To: T10 Technical Committee  
From: Steven Fairchild, HP ([steve.Fairchild@hp.com](mailto:steve.Fairchild@hp.com))  
Date: 9 September 2002  
Subject: Expander Configuration Details

The purpose for this document is to define the topology addressing details for the edge and fanout expanders. Most of the wording is to clarify existing concepts, with the exception of a new section on configuration of expander route tables within edge and fanout devices.

Figure X – Expander device constructed with expander components

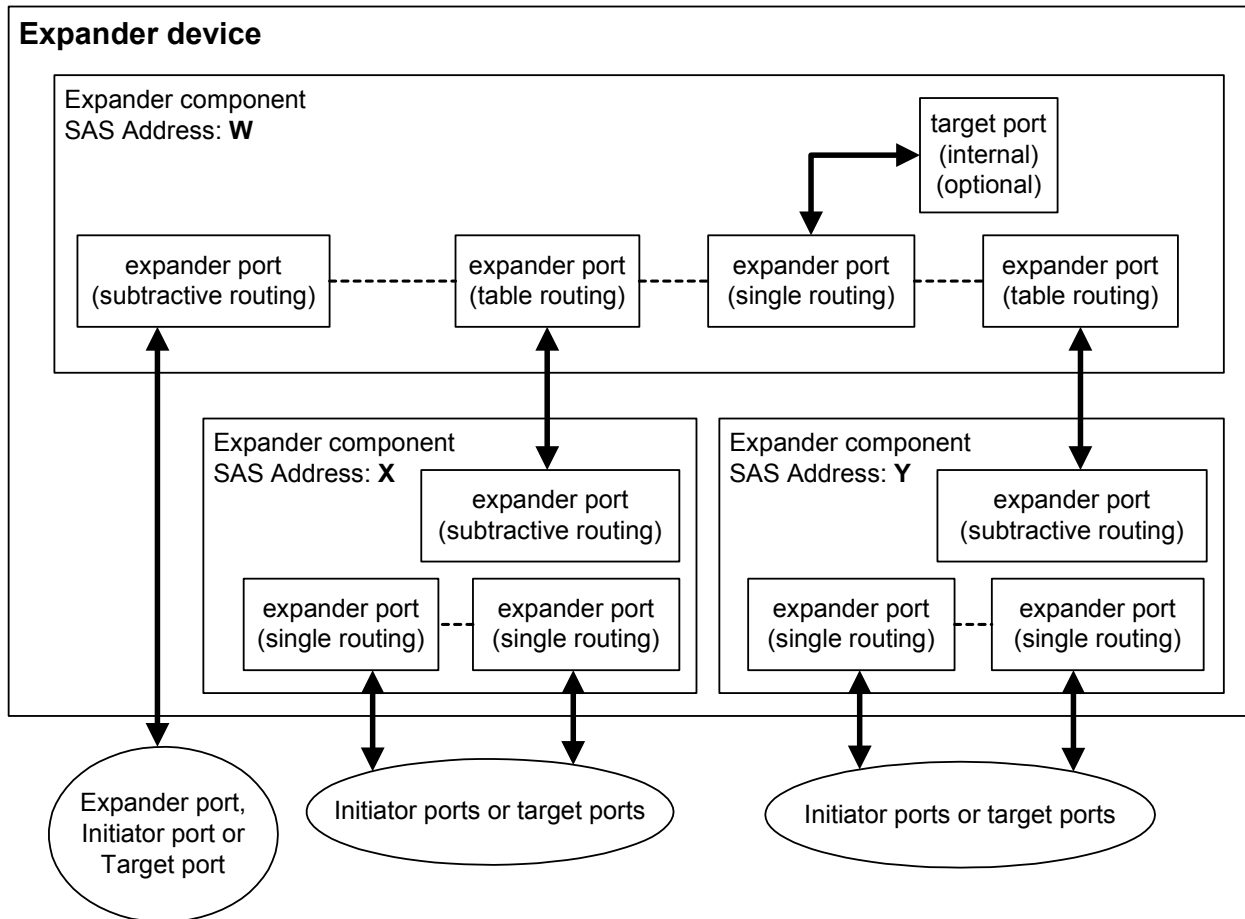
#### 4.1.7.1 Expander components

Expander devices may be constructed from one or more expander components. Expander components contain two or more external expander ports. Expander components may also include initiator ports and target ports attached to internal expander ports.

Figure X shows expander components used to construct an expander device.

An expander device that is constructed of expander components shall have a SAS address identifying each of the expander components. The expander components used to construct expander devices shall be detectable and addressable by their respective SAS addresses during the discovery process (see 4.1.9.2).

Figure X – Expander route table example

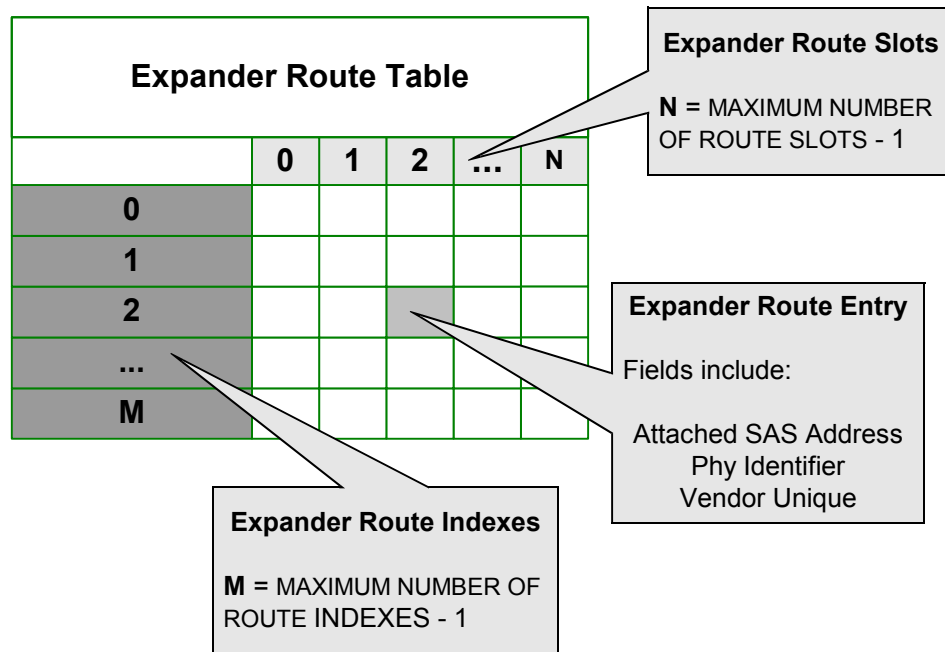
**4.1.9.1.1 Expander route table**

An expander device that supports the table routing method (see 4.1.9.1) shall contain an expander route table. The expander route table is an organized structure that provides an association between destination SAS addresses and expander ports. Each association is an expander route entry.

The initiator device references a specific expander route entry within an expander route table by using the EXPANDER ROUTE SLOT and EXPANDER ROUTE INDEX fields in the SMP REPORT ROUTE INFORMATION or SMP CONFIGURE ROUTE INFORMATION functions.

Figure X shows a logical representation of an expander route table with the elements identified.

Figure X – Edge Expander, "E1"

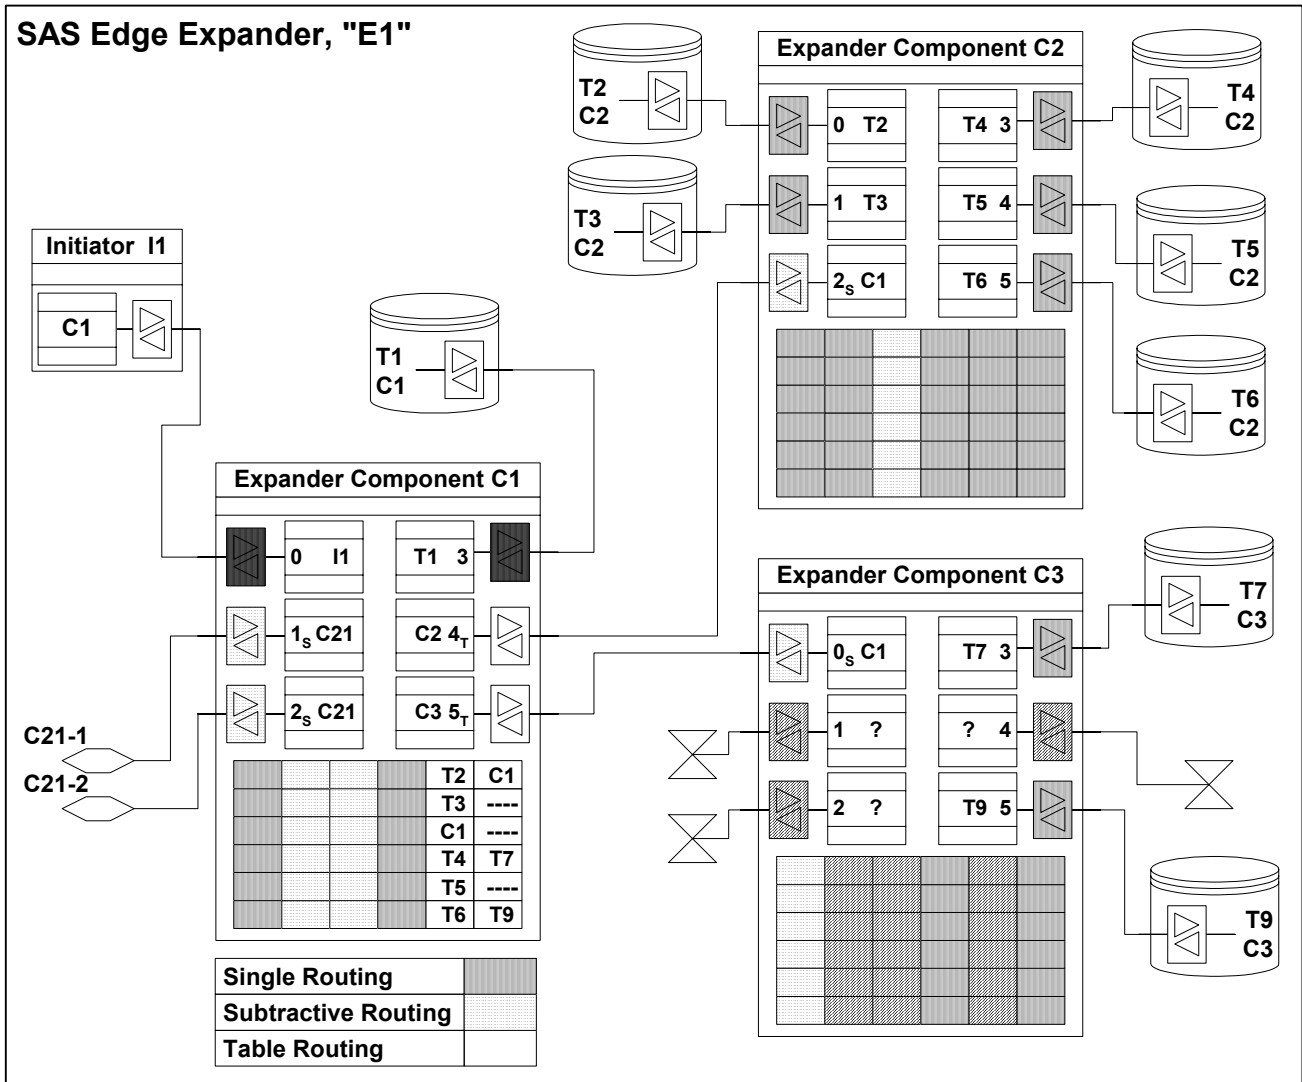
Figures X, Y and Z show an example topology, which is used to describe the discovery process.

Using Figure X as an example, initiator (I1) shall have completed the equivalent of Table X after traversing the edge expander (E1).

Figure Z – Fanout Expander, "F1"

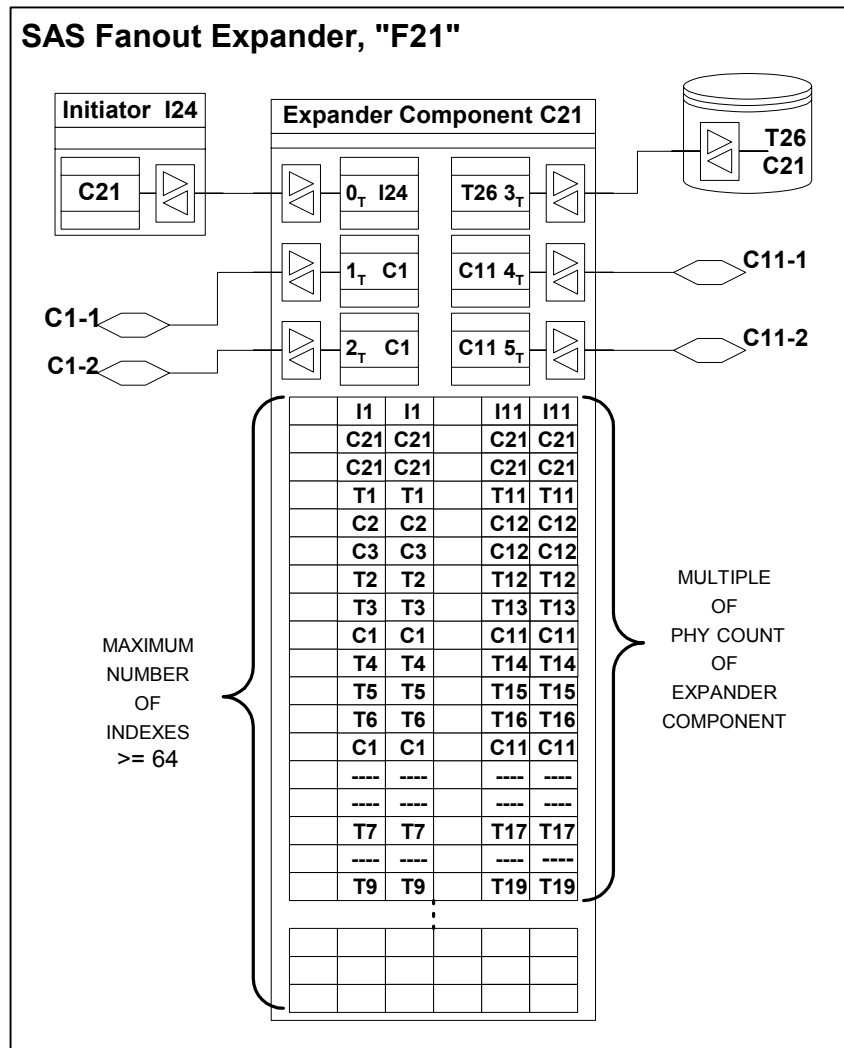
Using Figure Z as an example, initiator (I24) shall have completed the equivalent of Table Y after traversing the fanout expander (F1) and encountering the configurable edge expanders (C1 and C11).
